ADDENDUM NO. 2

**BRANDYWINE SCHOOL DISTRICT
CLAYMONT ELEMENTARY SCHOOL RENOVATION
BID PAC B
3401 Green Street, Claymont, DE 19703**

**THE WHITING-TURNER CONTRACTING COMPANY
CONSTRUCTION MANAGER
131 Continental Drive – Suite 404
Newark, DE 19713
302-292-0676**

SECTION 23 75 00 - CUSTOM-PACKAGED OUTDOOR HVAC EQUIPMENT

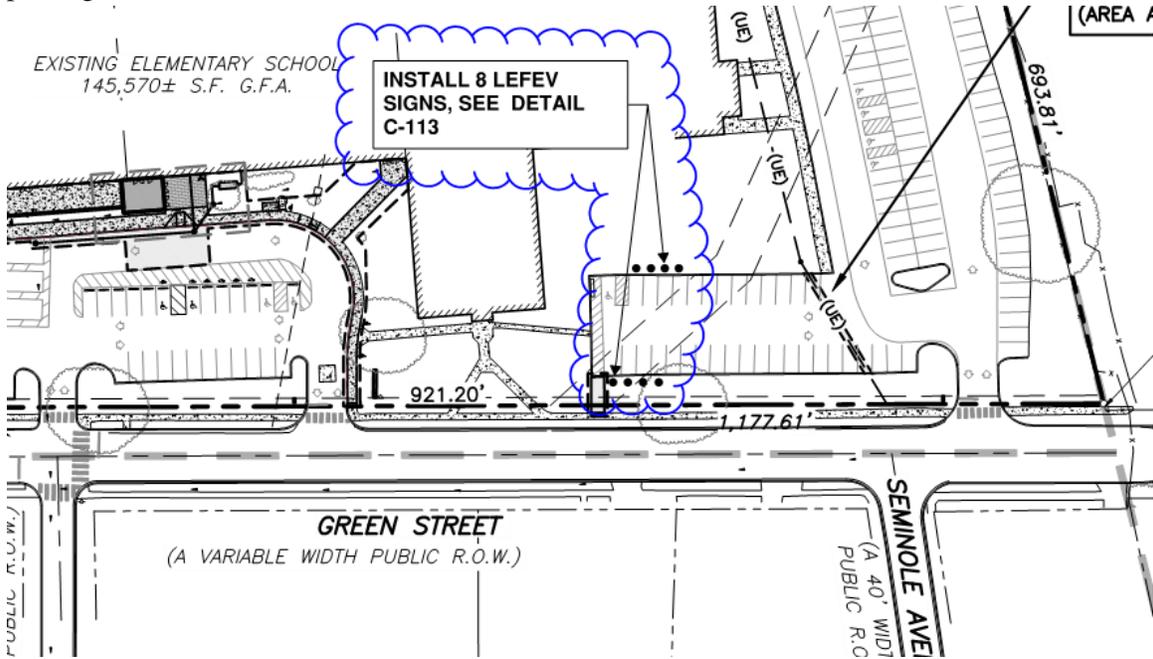
- a. Page 237500-1, Paragraph 2.1.A: ADD paragraph:
“A. MANUFACTURERS.”

DRAWING C-107

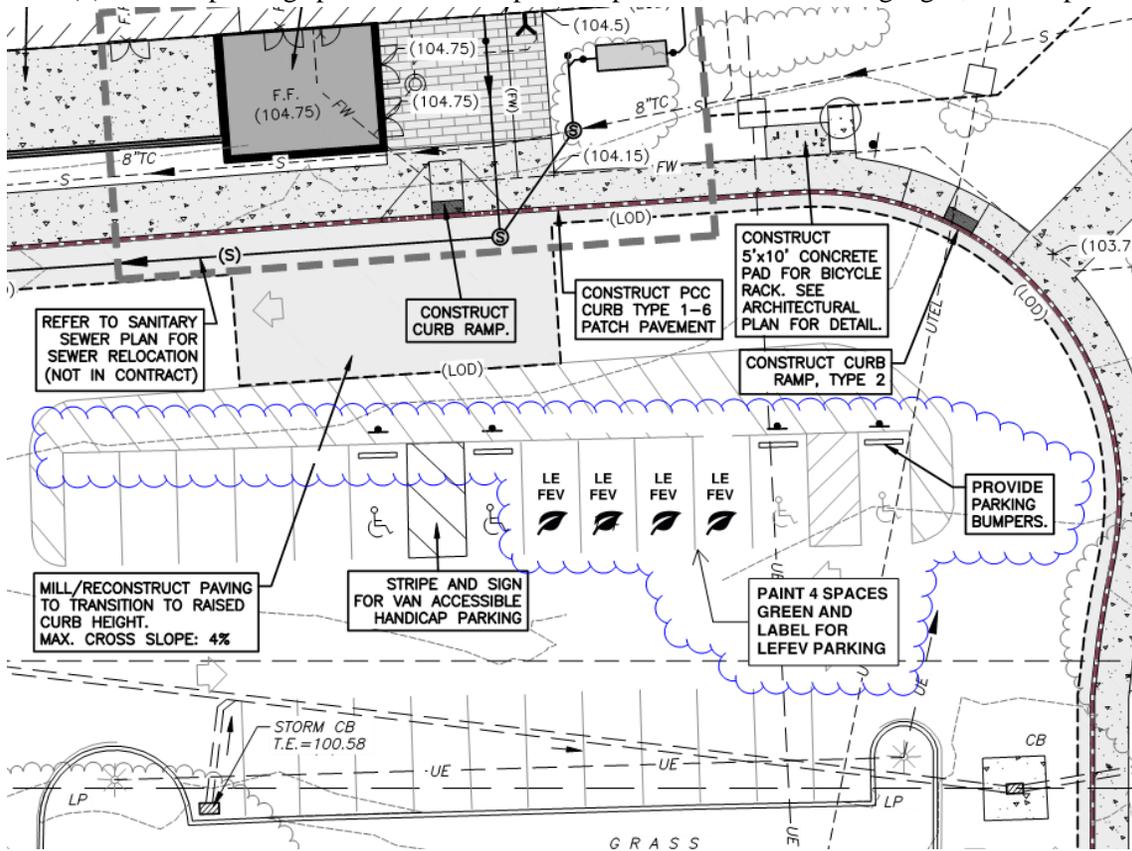
ADD two (2) signs for ADA parking spaces. Provide 4 new bumpers at ADA parking spaces.
Four (4) LEFEV parking spaces will be striped and painted, no freestanding signs, no bumpers.
